Eastern Regional Power Committee

Sub: Minutes of the 154th PCC meeting held on 20.01.2026

MINUTES OF 154th PROTECTION COORDINATION SUB-COMMITTEE MEETING HELD ON 20TH JAN 2026 AT 10:30 HRS THROUGH MS TEAMS

OBSERVATION

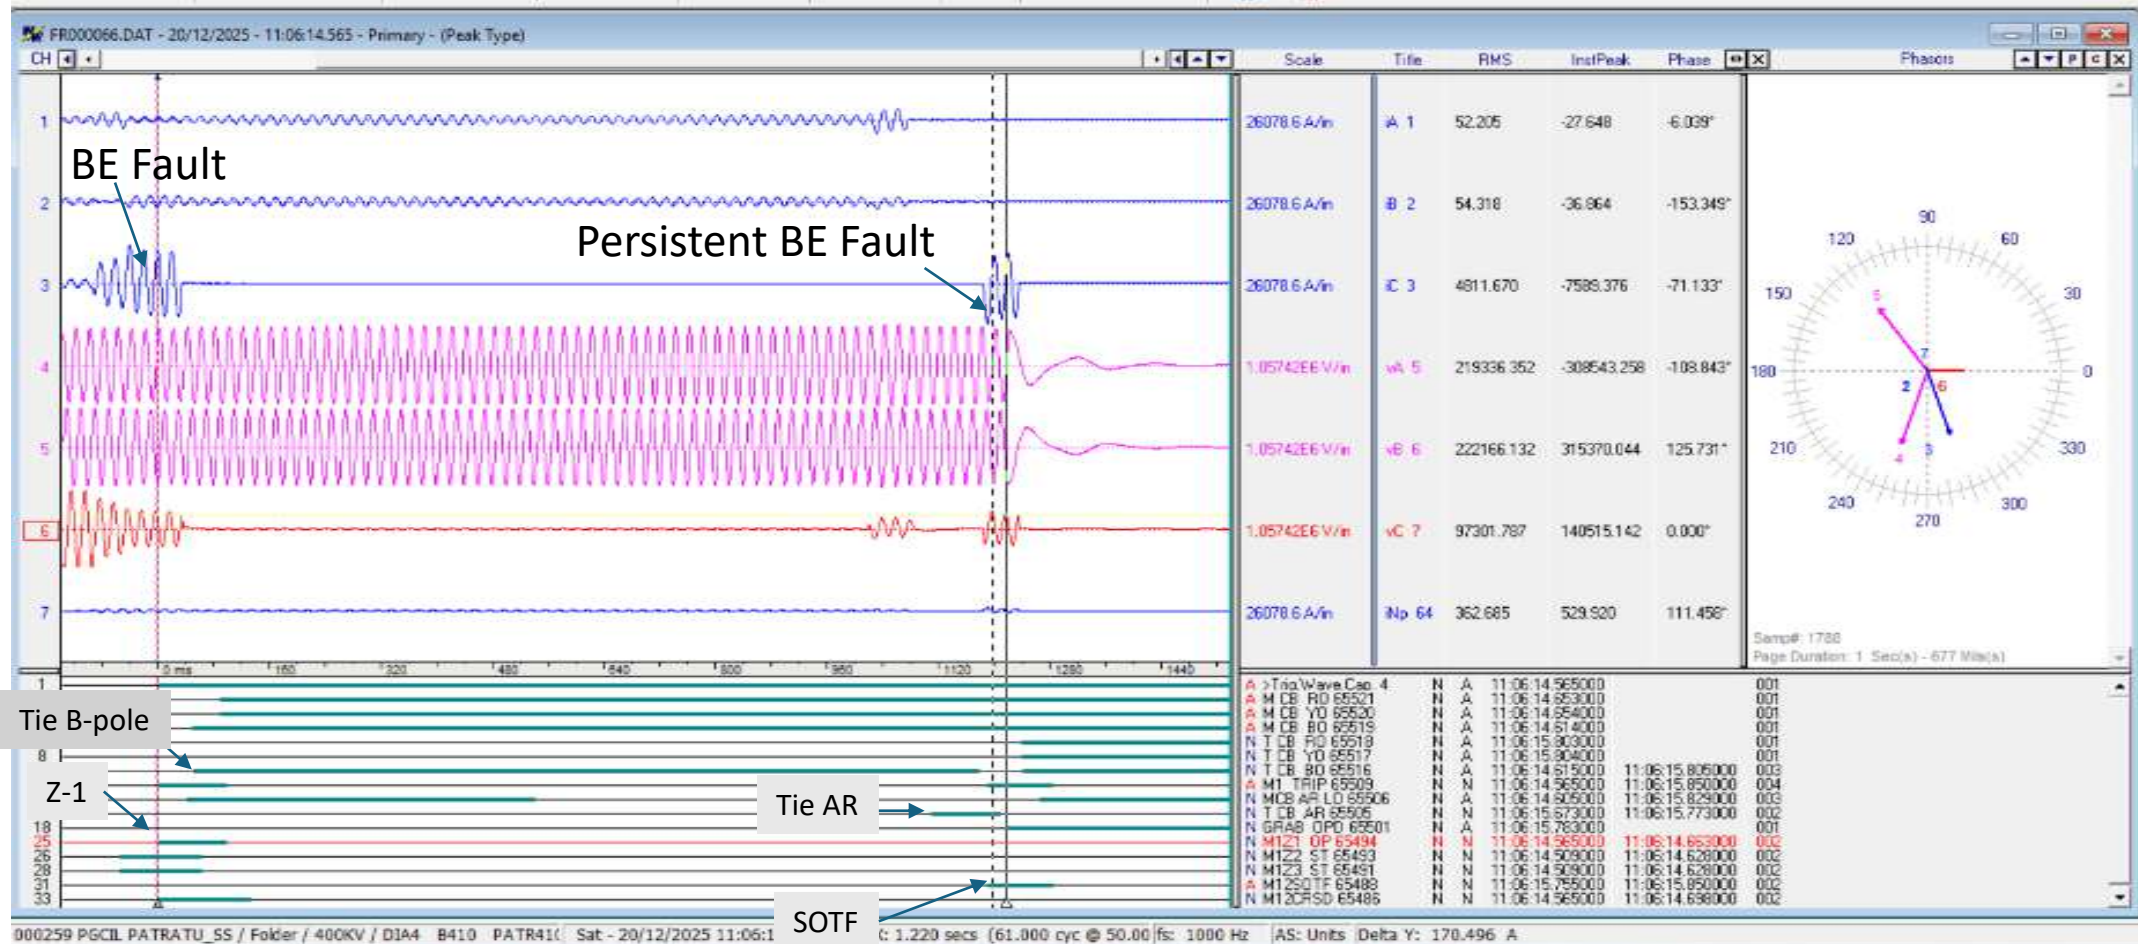
Protection Issues-

1. BB-1 and LBB operation inferred to be un-intended protection operation, which was initiated from 400 kV Patratu – PVUNL - 02 bay. It seems that there was some setting/wiring issue for LBB/ BB protection in PVUNL bay-2.
2. Complete verification of the entire BB protection wiring is required and issue to be resolved at earliest to prevent re-occurrence. After implementing the necessary corrections, busbar stability test shall be conducted to confirm healthy operation.

1. Since A/R was unsuccessful due to persistent fault on 400 kV Patratu- New Ranchi-1 Line, charging attempt should be under taken by SLDC only after thorough patrolling and confirmation of fault clearance by Line maintenance crew.
2. While permitting shutdown of the 400 kV Patratu–New Ranchi-1 line, PVUNL generation should be restricted to avoid SPS operation of 400kV Tenughat-PVUNL line and N-1 compliance in 220kV network.
3. Lack of proper maintenance of the line, resulting snapping of conductor with power flow 400 MW only. Last thermo-vision scanning report, maintenance of line/tightening of all joints need to be reviewed as per CEA regulation.

Figure 1: Network across the affected area

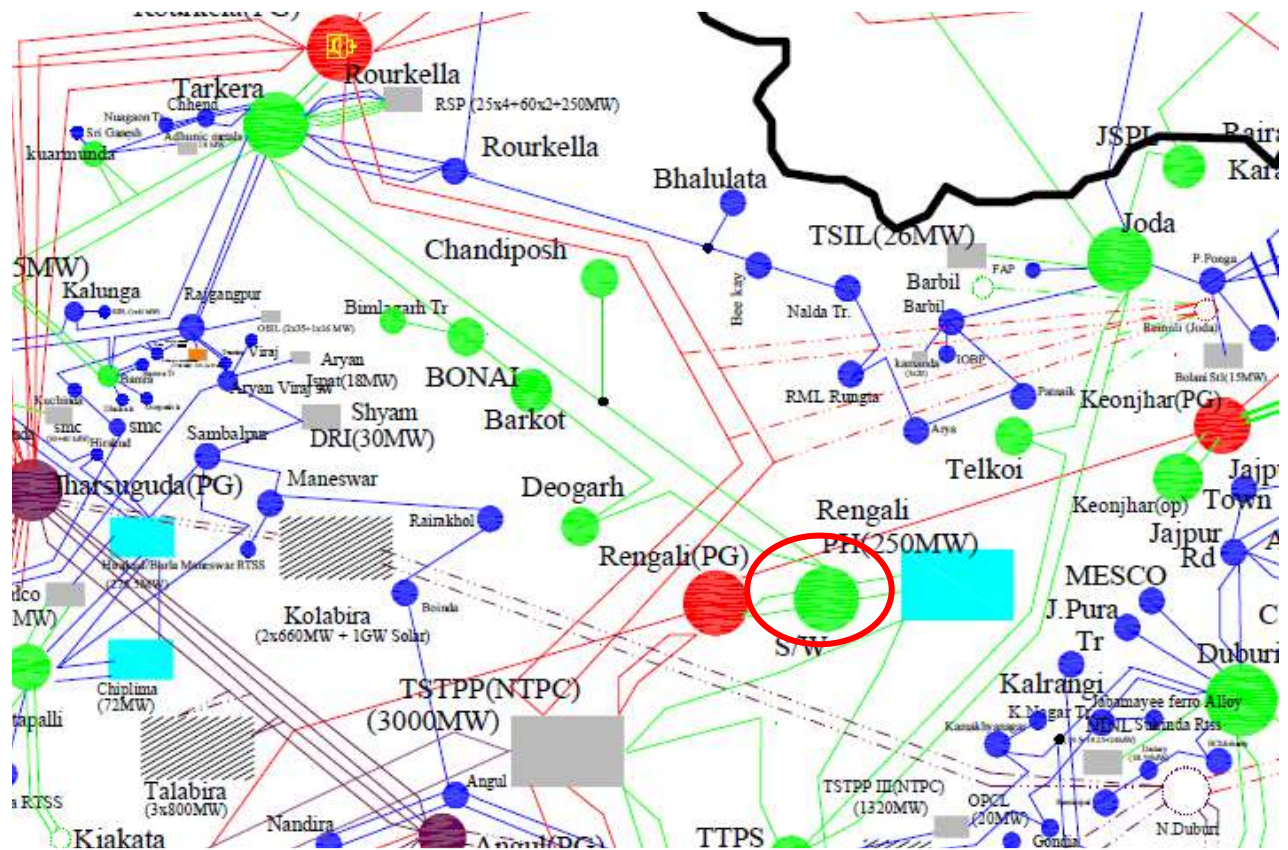
- Prior to the disturbance, 220kV Main bus #2 was under S/D condition and 220kV Rengali PH #2 and 220kV Rengali PG #2 was in idle charged condition from Rengali S/s.
- At 19:05:17 Hrs, Y phase Bus-1 side post insulator of 220 kV Bus coupler bay at Rengali S/s snapped, resulting in a Y-Earth bus fault at Rengali S/s.
- The 220kV Rengali PG #2 line tripped on O/C Earth fault Stg-2 protection after 100 msec.
- The 220kV Tarkera feeder tripped from Tarkera end on Z-2 protection.
- The 220kV Rengali PH #2 line sensed the fault in Z-4 protection and tripped after 250 msec. (Bus bar protection was not in service at the time of event).
- Simultaneously, Rengali PH unit 1 & 2 got tripped due to REF operation of GT.
- Due to tripping of all emanating lines, the 220kV Rengali S/s became dead.
- Total load loss of 49 MW reported at Rengali S/s.

- Non segregation of feeders between two main buses in the absence of feeder-wise voltage selection relay and BB protection has significantly reduces the reliability of Rengali SS. Uniform distribution of feeders on both buses is recommended to effectively utilise the double main bus scheme to enhance reliability. Further, installation of BB protection is required in accordance with Schedule-V, Section-4 of the CEA (Technical Standards for Construction of Electrical Plants and Electric Lines) Regulations, 2022.

- As intimated only B/U protection is presently available for the 220 kV Rengali-Rengali PG lines. Line differential Protection needs to be provided, as the line length is less than 10 Kms, in compliance with CEA (Technical Standards for Construction of Electrical Plants and Electric Lines) Regulations, 2022.

Figure 1: Network across the affected area

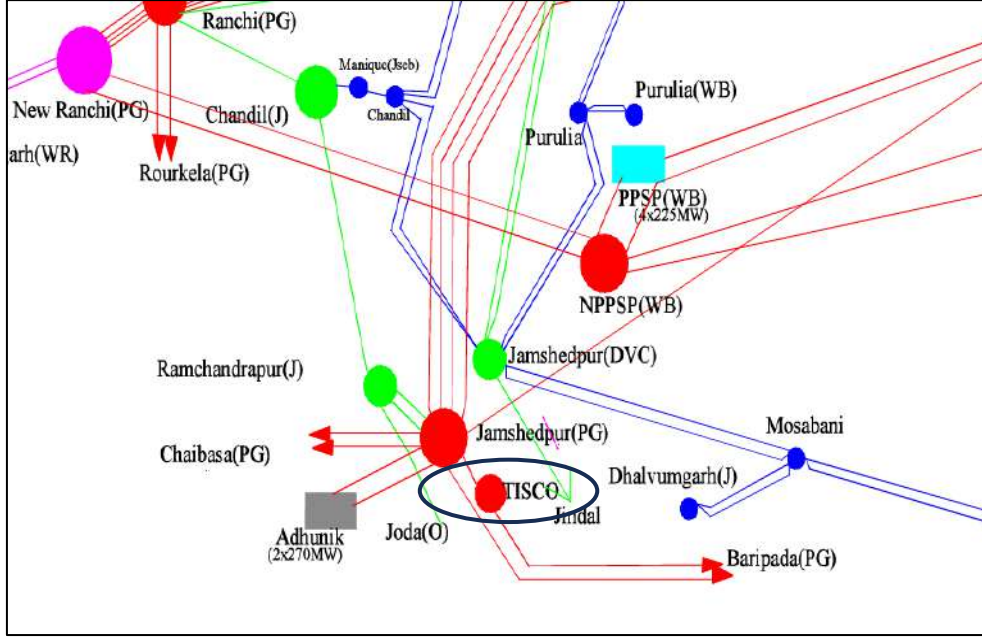
- Prior to the disturbance, TISCO Plant was radially connected through 400kV TISCO Jamshedpur line (400kV TISCO-Baripada line was under planned S/D)
- At 19:21:15 Hrs, during charging of 400kV TISCO-Baripada line from TISCO end, line got charged, while closing of line side isolator (*Tie CB at TISCO in stuck condition due to suspected control circuit issue at TISCO end*).

PCC advised TISCO representative to share the revised distance reach settings, directional earth fault settings, Zone-3 (Z3) time settings, at TISCO end to ERPC/ERLDC for review and further suggestion.

Figure 1: Network across the affected area

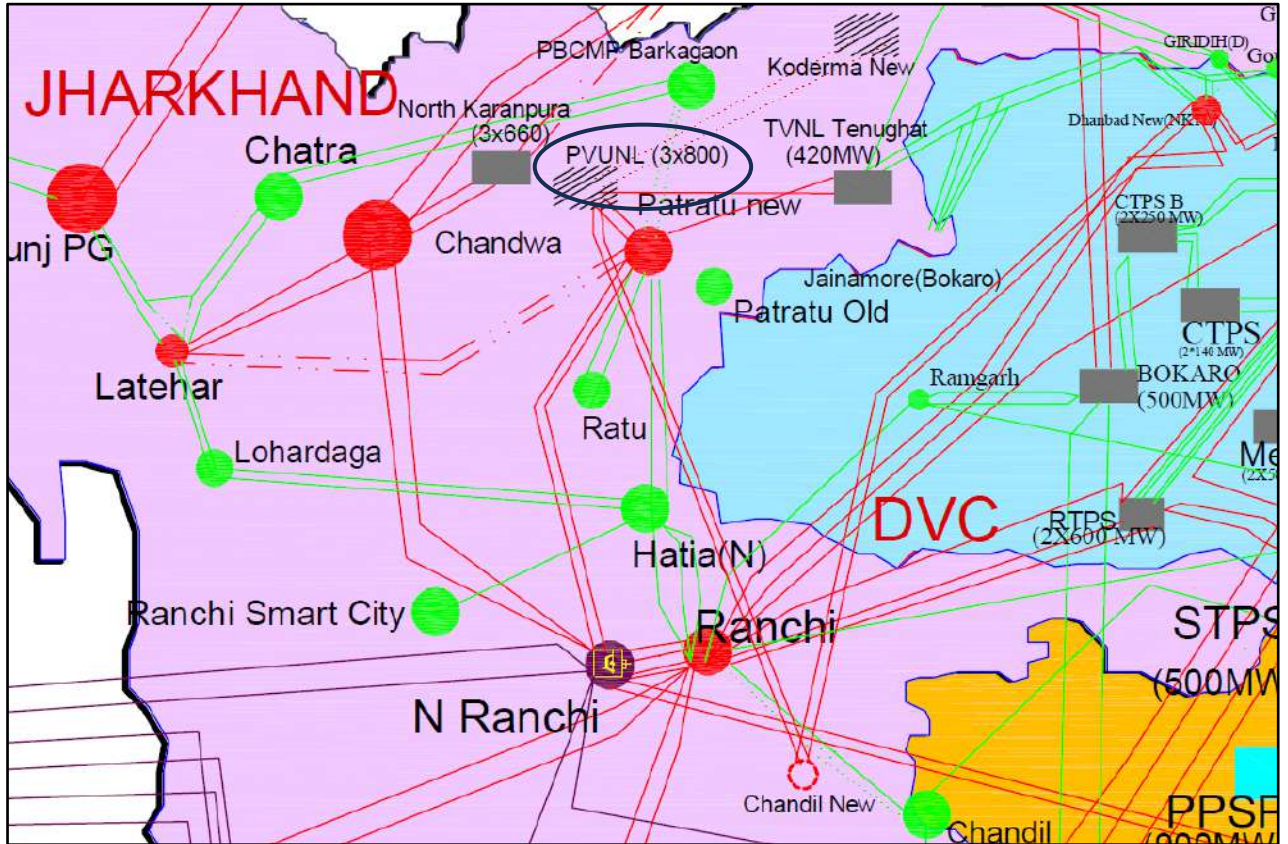
- Prior to event, PVUNL generation of around 665 MW was being evacuated through 400kV PVUNL-Patratu D/C and 400kV PVUNL-Tenughat line.
- 400kV New Ranchi-Patratu -2 line was under planned shutdown.
- At 11:06:15 Hrs on 20/12/25, B-E fault occurred on 400 kV Patratu- New Ranchi-1 Line due to snapping of conductor in between Loc No 27-28. A/R was attempted through Tie CB, but it was unsuccessful due to persistent fault after dead time of 1 sec.

- Following tripping of 400 kV Patratu- New Ranchi-1 Line, 400 kV PVUNL-Tenughat Line tripped on SPS operation as per scheme (324 A). Subsequently, PVUNL generation was evacuated through 400 kV PVUNL-Patratu D/C and 400/220 kV ICTs at Patratu.

- At 11:23:28 Hrs, during charging attempt of the 400 kV Patratu-New Ranchi-1 from Patratu end, line tripped on SOTF due to permanent fault. Simultaneously, busbar/LBB protection operated at 400 kV Patratu substation, resulting in tripping of both 400 kV PVUNL-Patratu D/C lines on LBB/BB and DT receipt at PVUNL.

2	Whether DR/EL provided within 24 Hours?	1. IEGC section 37.2 (c) 2. CEA grid Standard 15.3	Submitted
3	Detailed Report received within 7 days?	IEGC section 37.2 (e)	Submitted
4	Protection system not operated correctly	CEA Technical Standard for Construction of Electrical Plants and Electric Lines: 48 (1) a. CEA (Technical standards for connectivity to the Grid) Regulation, 2007: Schedule Part 1. (6.1, 6.2, 6.3)	Unintended LBB/bus bar protection operated at Patratu S/s.

1. Preventive maintenance of the transmission line, including thermos-vision scanning and tightening of all loose joints in accordance with CEA Grid Standard regulation 2010 is essential to prevent incident such as snapping of ACSR twin moose conductor (flow 400 MW). Periodic checking of all protection settings through both internal reviews and Third-party Protection audit as mentioned in the Grid code, is required to avoid un-intended protection operation and to ensure system reliability.

Figure 1: Network across the affected area

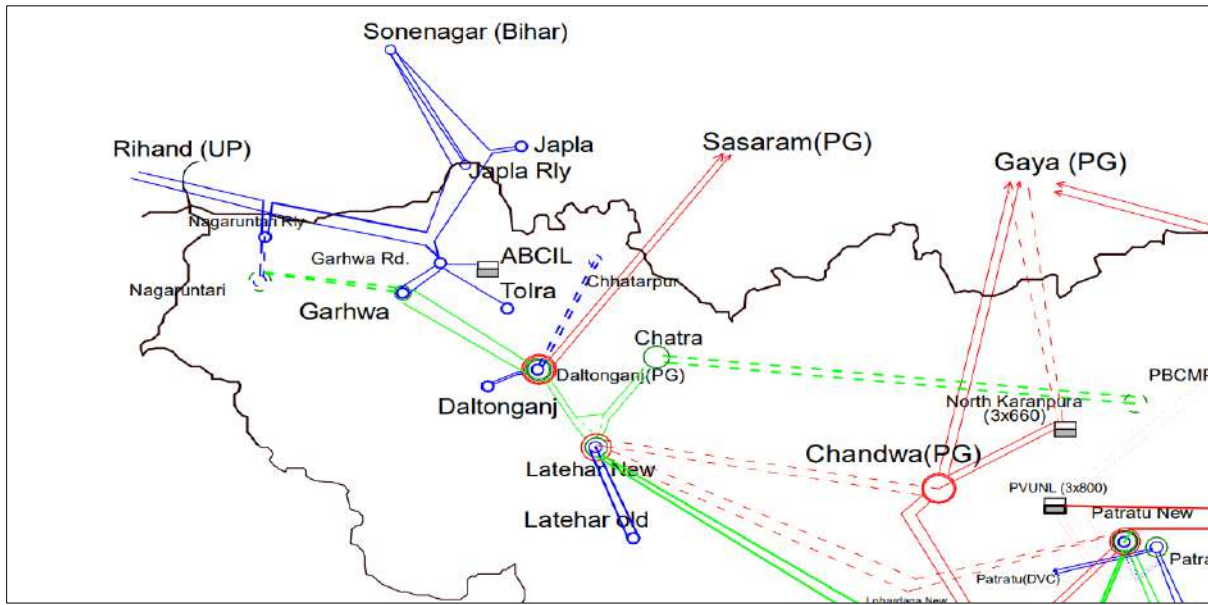
- Fault was occurred in 33kV bus side, which was partially cleared by 132/33kV ICT -1 but same fault was not sensed by 132/33kV ICT-2. As per report received from SLDC, Backup core CT polarity of 132 kV side of ICT-2 was found reversed. Issue resolved on 11/11/2025.
- Fault was occurred in 33kV network which was delayed cleared by 132/33kV ICT-1 and 220/132kV ICTs in 1.7 sec and 7.7 sec respectively. O/C earth fault setting of 220/132kV ICTs and 132/33kV ICTs may be coordinated.
- DR is not time synchronised.
- Detail Report received from SLDC is attached in Annexure.

- 220/132 kV ICTs and 132/33 kV Power Transformers back up setting weren't coordinated properly. The back settings are revised as follows –
